OAKLEY STREET HOUSING SUPPORT CENTER

RFB-DCB-01-26

ADDENDUM # 2

Re: Questions and Answers; updated technical specifications; updated drawings

**ELECTRICAL:
2ND FLOOR
CONSTRUCTION
COMMUNICATIONS PLAN**

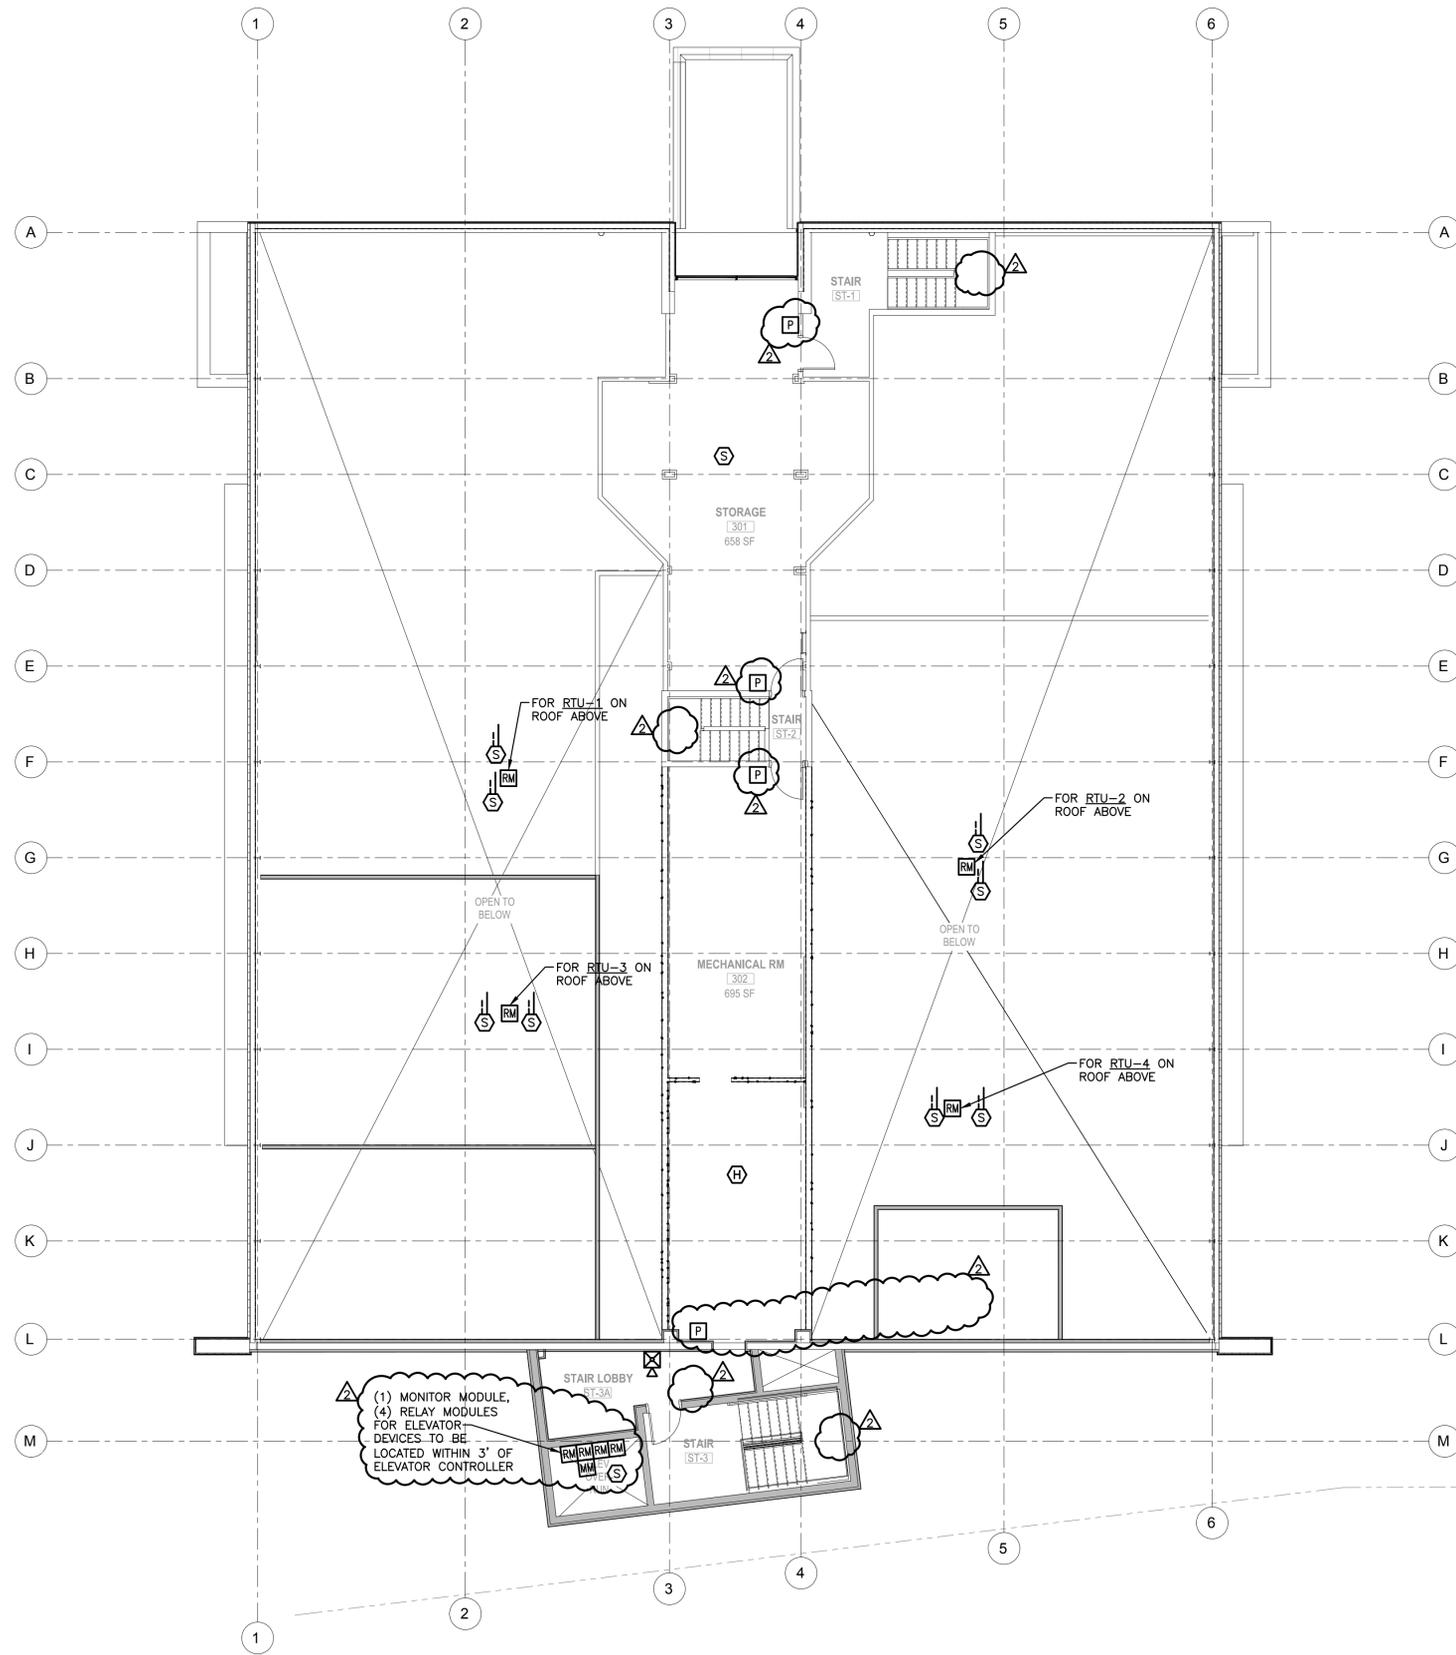
16. SHEET E-302:

- MAKE CAMERA LOCATIONS VISIBLE ON SHEET.
- ADD OUTDOOR-RATED HORN-STROBE TO OUTSIDE VESTIBLE V2A.
- RELOCATE PULL STATION FROM INSIDE STAIR TOWER TO CORRIDOR PRIOR TO ENTERING STAIRTOWER.
- DELETE STROBE FROM STAIRWELL ST-3.
- DELETE STROBE FROM STAIRWELL ST-1.
- DELETE PULL STATION FROM STAIRWELL ST-1.

**ELECTRICAL:
3RD FLOOR
CONSTRUCTION
COMMUNICATIONS PLAN**

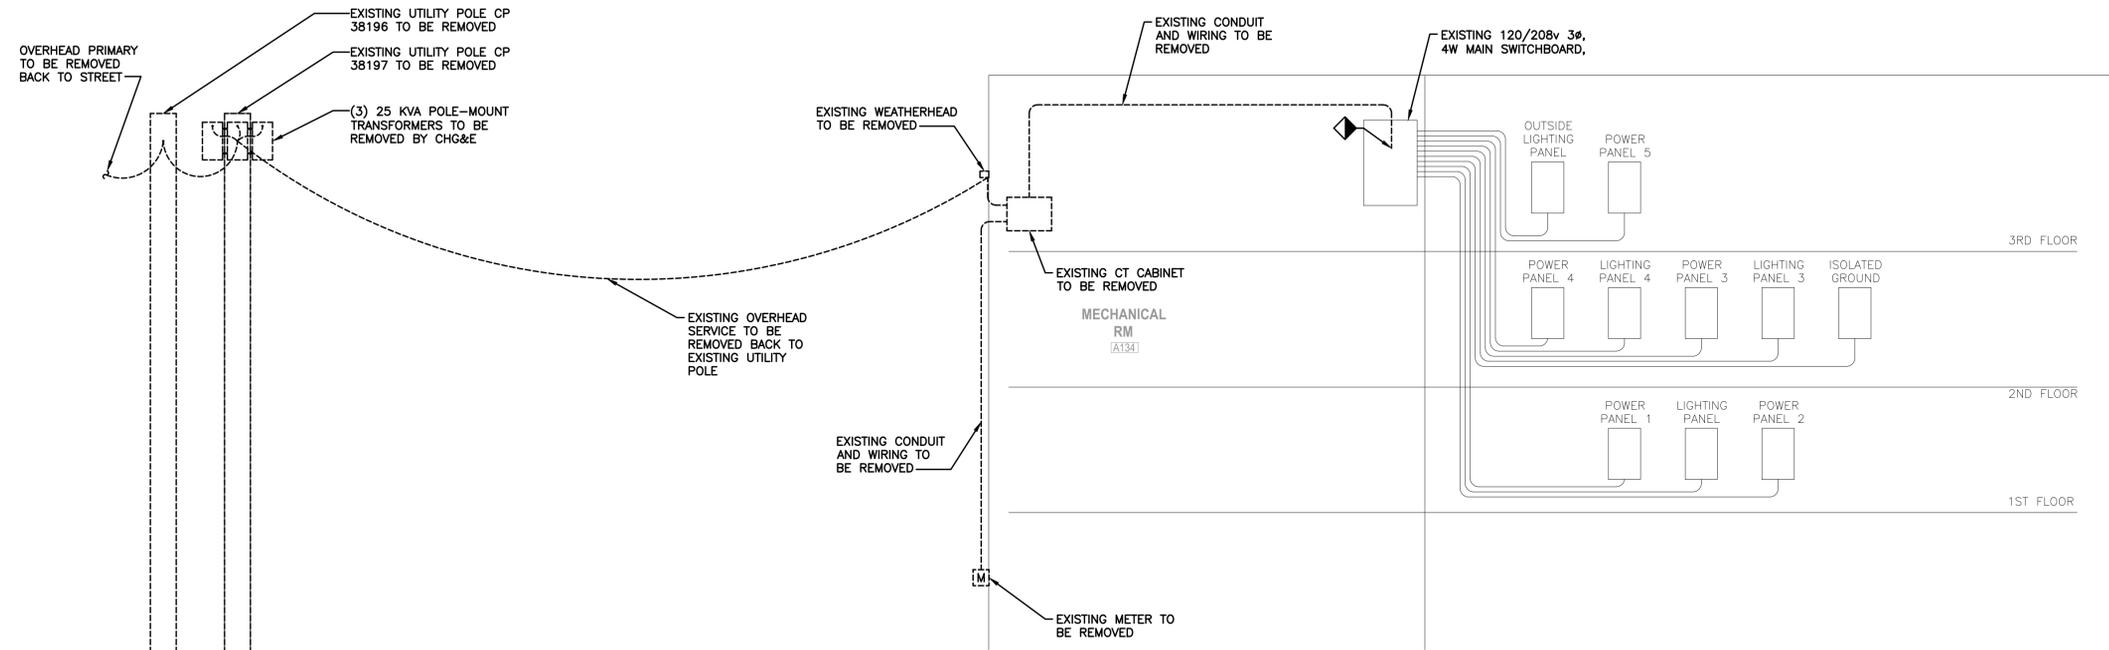
17. SHEET E-303:

- DELETE STROBE FROM STAIRWELL ST-1.

ELECTRICAL: ONE-LINE DIAGRAMS

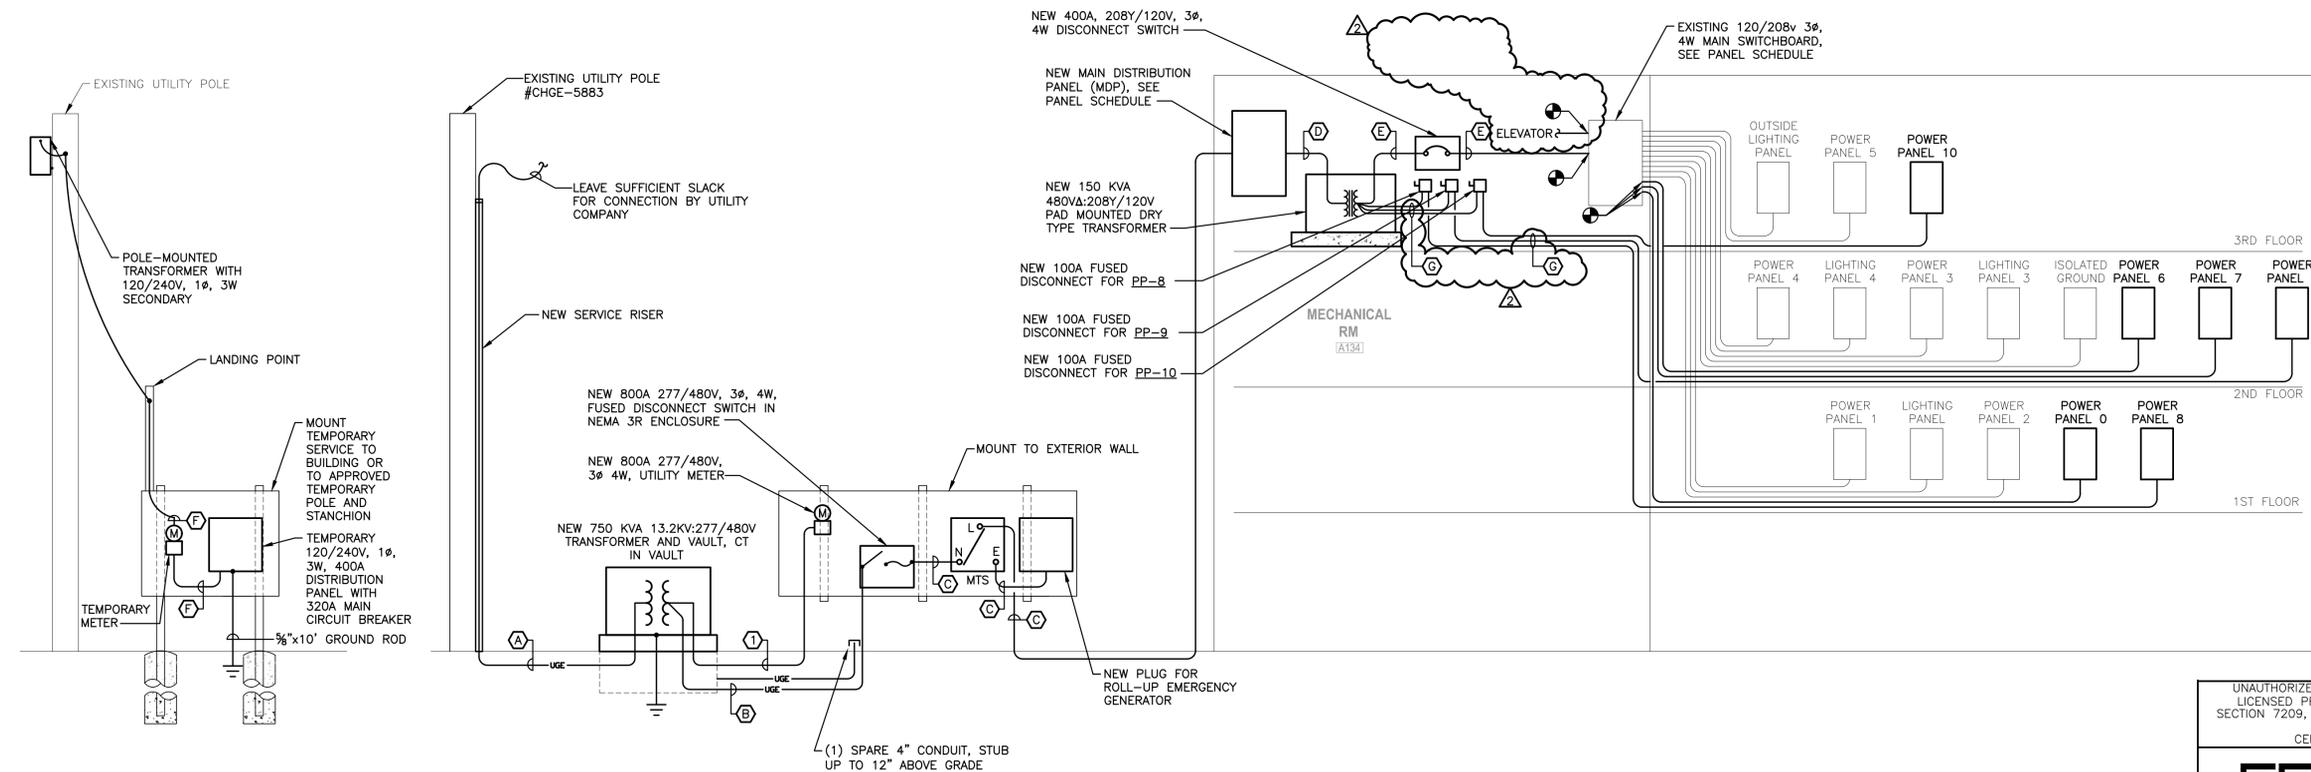
18. SHEET E-601:

- DELETE SHUNT-TRIP CIRCUIT BREAKER FOR ELEVATOR.
- ADD TAG G TO WIRE AND CONDUIT SCHEDULE.
- ADD TAG G TO FEEDERS FOR POWER PANELS 8, 9, 10.

STOREFRONT / WINDOW TYPES & DETAILS

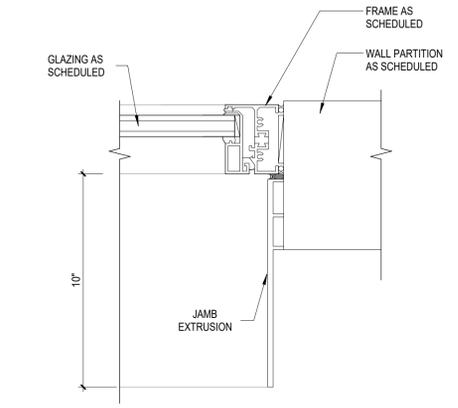
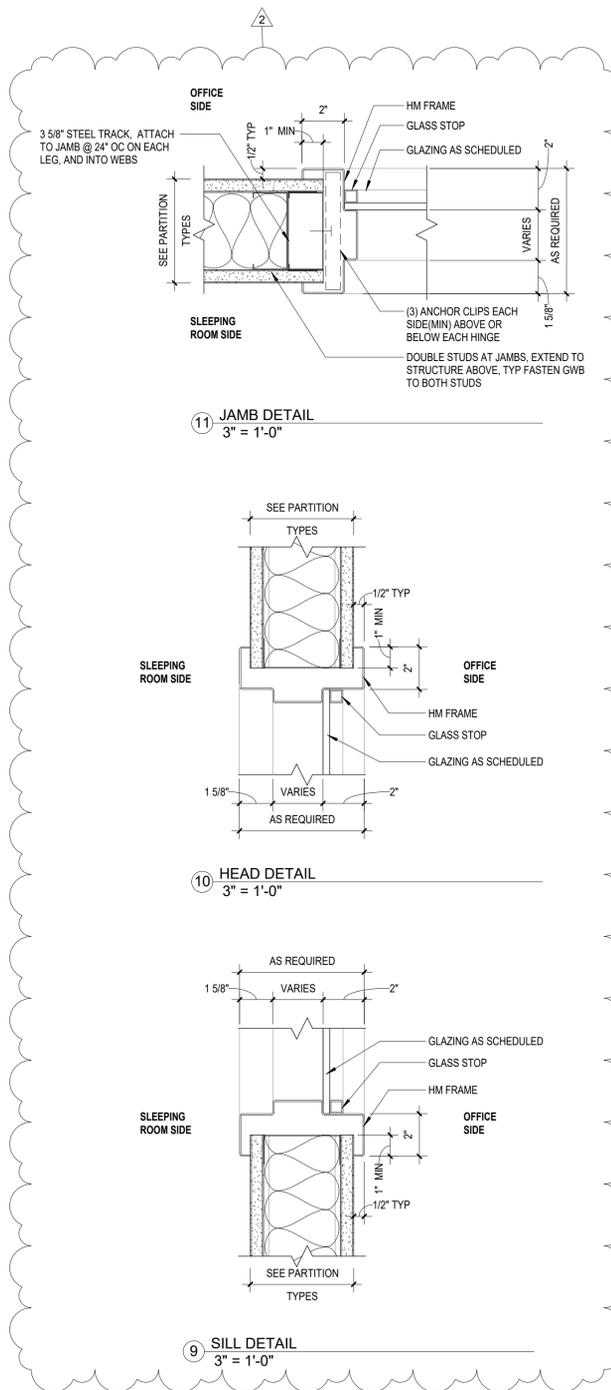
- Q18: At the first floor, in the room Operator Offices 118, there is an opening marked W10. This window opening marked W10 is not showed anywhere in the drawings Please clarify what kind of opening is this and please provide an elevation and details for it.

- Q28: First Floor Plan A-101 tags a W10 window at Operators Office 118. This window is not on the page A-801. Please clarify.
- A28: Refer to revised sheet A-801 / A-802 for elevation and details for Window Type W10.**

- A18: Refer to revised sheet A-801 / A-802 for elevation and details for Window Type W10.**
- Q19: At the second floor, in the room Sleeping (men) 208, there is an opening marked W1a. What 's the difference between window type W1 and type W1a? And what's the difference between window type W1 and type W2? Please clarify what kind of opening is this and please provide an elevation and details for it.

- A19: Refer to revised sheet A-801 / A-802 for elevation and details for Window Type W1a. The difference between window type W1 and W2 is the exterior finish and the requirement for jamb / sill / head extensions to accommodate the Trespa rainscreen assembly.**

- A24: All interior windows located in rated walls (1-hr) are to be Hollow Metal Framed with a 20-minute Fire-Rating.**
- Q25: There is no reference to fire rated glazing in section 088000 nor is there a separate fire rated glazing section. Please clarify specification for fire rated glazing.

- A33: Refer to revised sheet A-801 / A-802 for elevation and details for Window Type W10.**
- Q34: Reference Drawing A803: Door Tag 202b is shown as a single door however, A-102 indicates a double door. Furthermore, Hardware Set "B" is identified for Door Tag 202b however, Hardware Set B is not listed in the specifications.

8 JAMB DETAIL - WINDOW
3" = 1'-0"

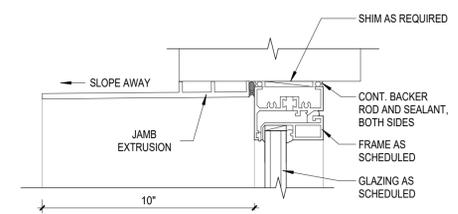
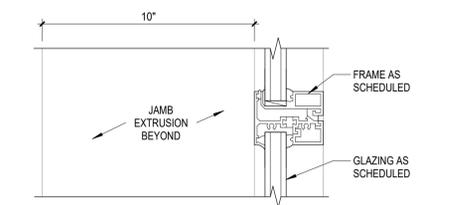
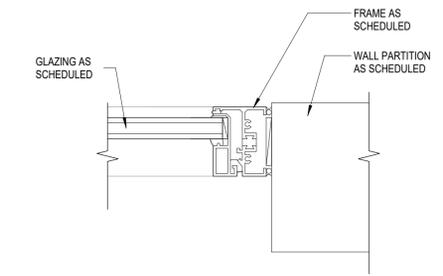
- Q27: Exterior Elevation A-302, Note 16 and 16a - Jamb Extrusions. Are these to be at jambs, heads AND sills, as shown on details 5, 7, and 8 on drawing A-802?

- A27: Extrusions for windows within the Trespa rainscreen assembly are to include jambs, sills, and head sections. Refer to additional details on sheet A-802.**
